Service Bulletin

Bulletin No.: 21-NA-265

Subject: Coolant Leak Under Truck, Malfunction Indicator Lamp (MIL) Illuminated - DTC P2C48 Set

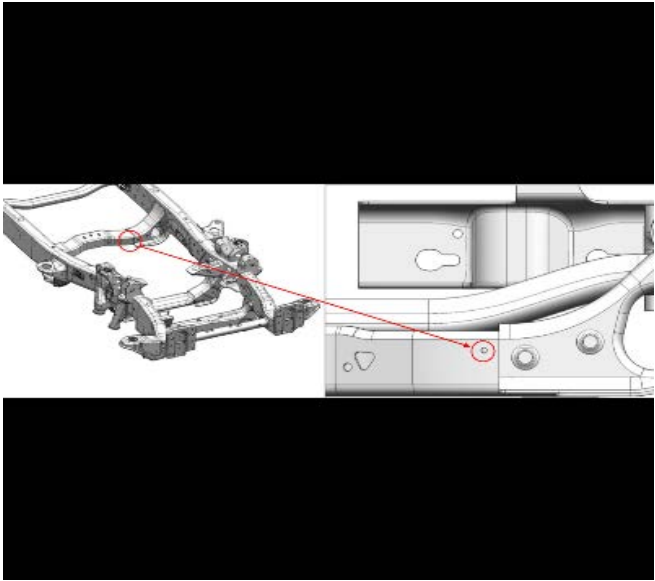
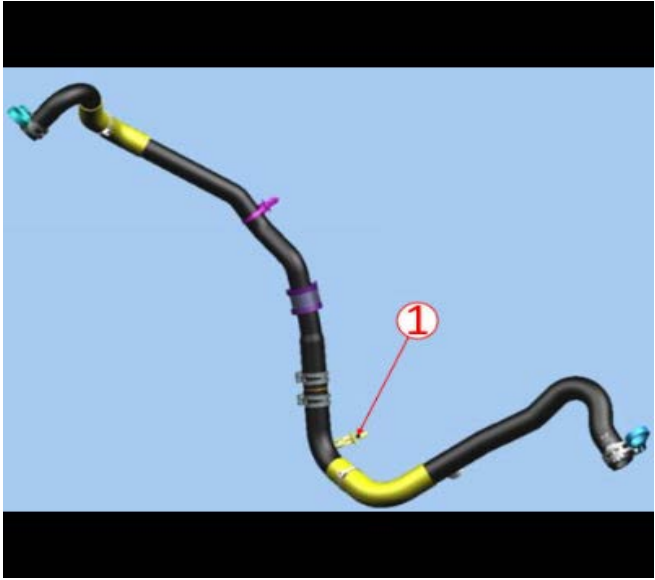
<p>Cause</p>	<p>This condition may be caused by the fuel cooler coolant hose contacting front drive shaft at crossmember. – Typically can happen when driving through deeper water or snow.</p>
<p>Correction</p>	<p>Follow the procedure below to re-route the coolant hose away from the front drive shaft:</p>  <p style="text-align: right;">5924533</p> <ol style="list-style-type: none"> Utilizing a 6.5 mm drill size, drill a hole in the transmission crossmember in the approximate location noted in the graphic above.  <p style="text-align: right;">5924534</p> <ol style="list-style-type: none"> Add retainer or equivalent, onto the hose. Install retainer into the hole in the crossmember.

Causal Part	Description	Part Number	Qty
N/A	Retainer	13596790 (Hollingsworth)	1
